Access Compliance Report

Public Rights-of-Way

(Curb Ramps)

Intersection ID: 9847	Main Street: BLACKWOOD_AV	Cross Street: THE_PLAZA	Location: SE
ADA ID: D98AA87639D4	Ramp Type: Perp	Initial Pass/Fail: Fail	Overall Compliance: No
		Severity Score: 10

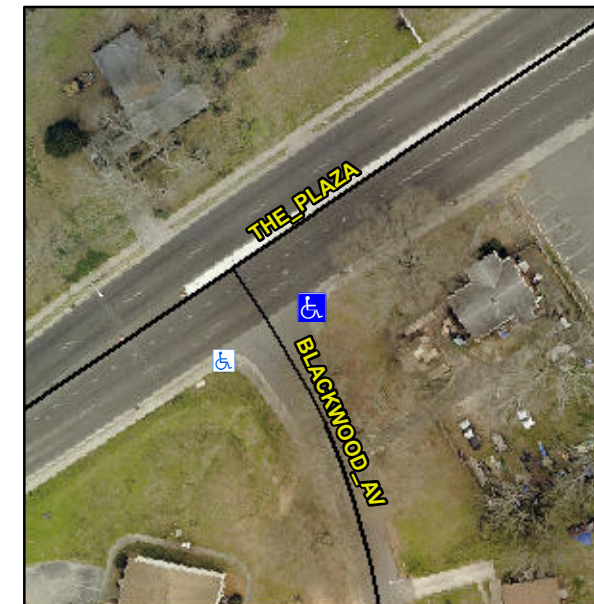
Not Found, R304.5.1, R304.5.3

Compliance	Description	Data	Compliance	Description	Data
N/A	Ramp Length (in)	60.0	Yes	Ramp Slope (%)	7.7
No	Ramp Width (in)	44.0	No	Ramp XSlope (%)	2.4
N/A	Flare Type LT	N/A	N/A	Flare Type RT	N/A
N/A	Flare Slope LT (%)	N/A	N/A	Flare Slope RT (%)	N/A
N/A	Flare Traversable LT?	N/A	N/A	Flare Traversable RT?	N/A
N/A	Landing Length (in)	N/A	N/A	DWS Provided?	N/A
N/A	Landing Width (in)	N/A	N/A	DWS Contrast?	N/A
N/A	Landing Slope (%)	N/A	N/A	DWS Length (in)	N/A
N/A	Landing X Slope (%)	N/A	N/A	DWS Full Width?	N/A
N/A	Landing Curb? (Y/N)	N/A	N/A	DWS Offset (in)	N/A
N/A	Shared Landing?	N/A			
N/A	Gutter Ponding?	N/A	N/A	Gutter Slope (%)	N/A
N/A	Gutter Lip Ht (in)	N/A	N/A	Gutter X Slope (%)	N/A
N/A	Painted X Walk1?	No	N/A	Painted X Walk2?	N/A
	X Walk 1 Direction	To SW		X Walk 2 Direction	N/A
N/A	X Walk 1 Width (in)	N/A	N/A	X Walk 2 Width (in)	N/A
	X Walk 1 Slope (%)	0.8		X Walk 2 Slope (%)	N/A
	X Walk 1 X Slope (%)	2.5		X Walk 2 X Slope (%)	N/A

Remove & Replace Entire Ramp.
